# UNITED STATES PATENT AND TRADEMARK OFFICE

APPLICATION NO.	FILING DATE	FIRST NAMED INVENTOR	ATTORNEY DOCKET NO.	CONFIRMATION NO.
10/808,360	03/25/2004	Samad M. Edlou	1857.0870001	4756
26111	7590	06/09/2006	EXAMINER	
STERNE, KESSLER, GOLDSTEIN & FOX PLLC 1100 NEW YORK AVENUE, N.W. WASHINGTON, DC 20005			LAVARIAS, ARNEL C	
			ART UNIT	PAPER NUMBER
			2872

**Office Action Summary**

**FIG. 3**

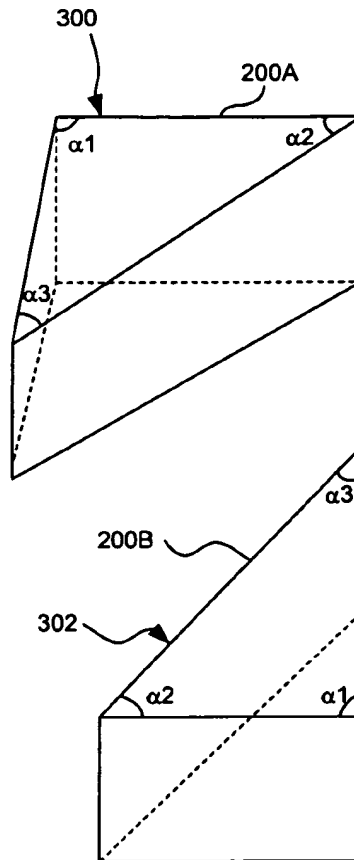
Figure 3- the arrow from reference numeral 300 is pointing to the incorrect surface of prism 200A. This arrow should point to the hypotenuse surface of the prism.
